Service Bulletin

Bulletin No.: 17-NA-221

Subject: Poor Engine Performance in Extremely Cold Weather Conditions for LE2 Engines, Charge Air Cooler (CAC) Icing - Malfunction Indicator Lamp (MIL) Illuminated, DTC P0299, P0236, P2227, P00C7 Set

Brand:	Model:	Model Year:		VIN:		Engine:	Transmission:
		from	to	from	to		
Buick	Encore	2016	2018	SOP	Sept. 18, 2017	LE2

3665598

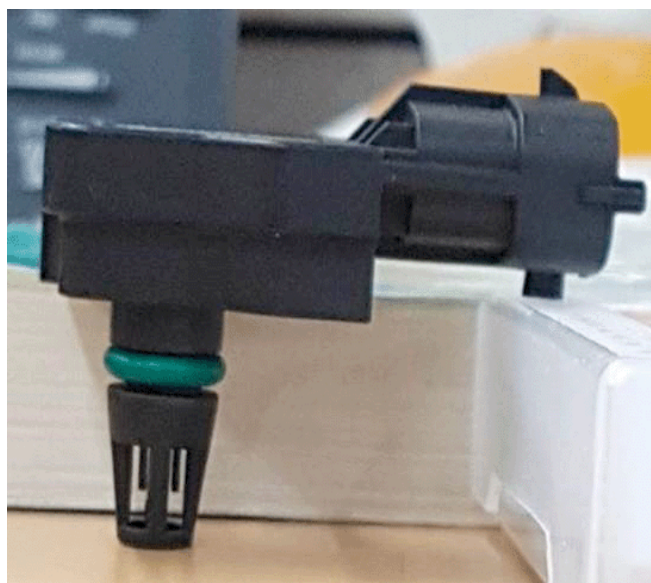
1. Remove the Intake Air Pressure and Temperature sensor (IAPT) (2). Refer to *Intake Air Pressure and Temperature Sensor Replacement* in SI.

2851444

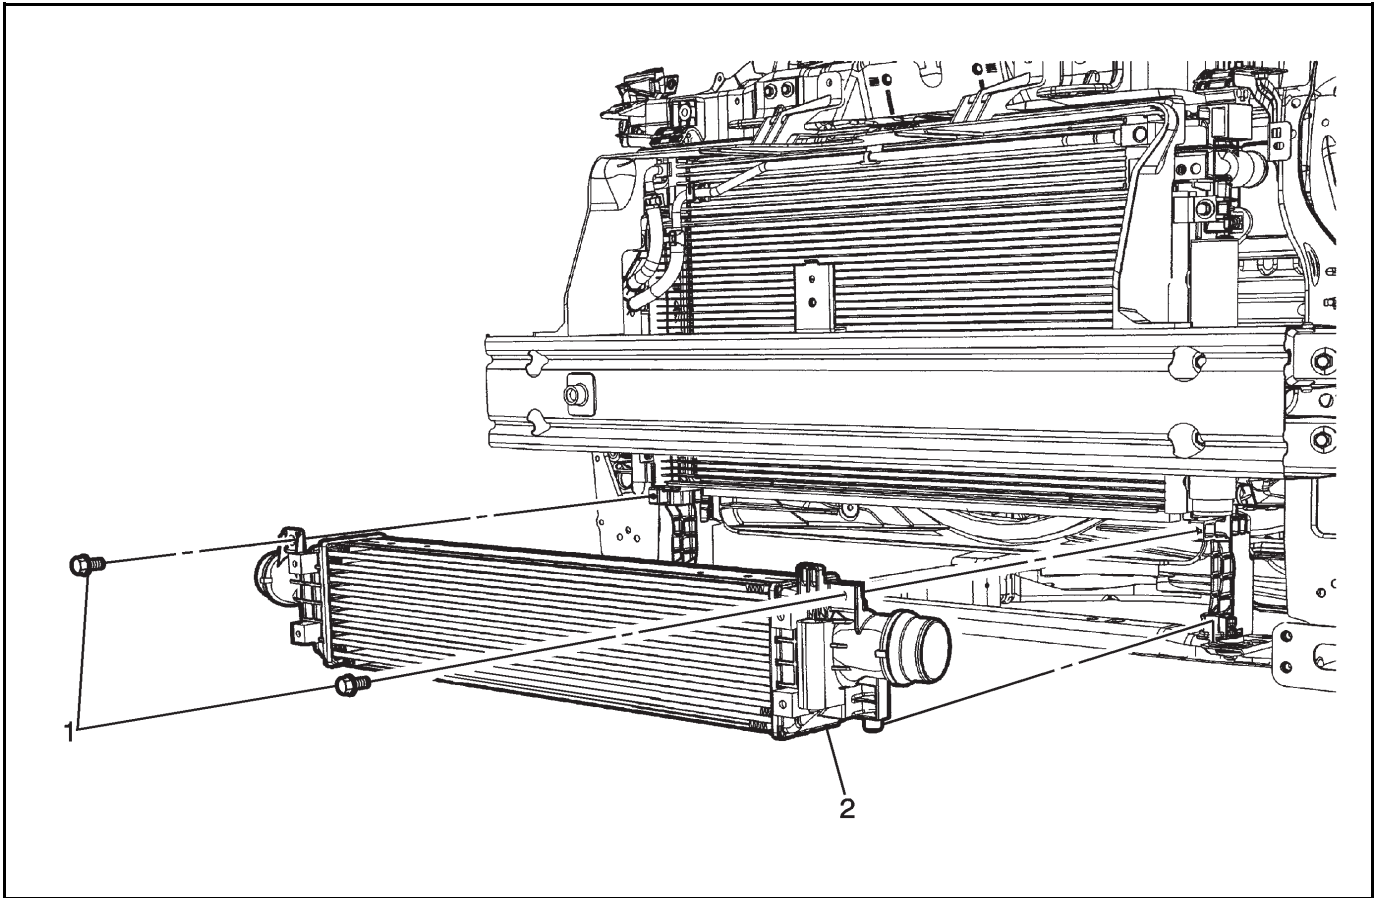
1. Install CAC (2). Refer to *Charge Air Cooler Replacement* in SI.
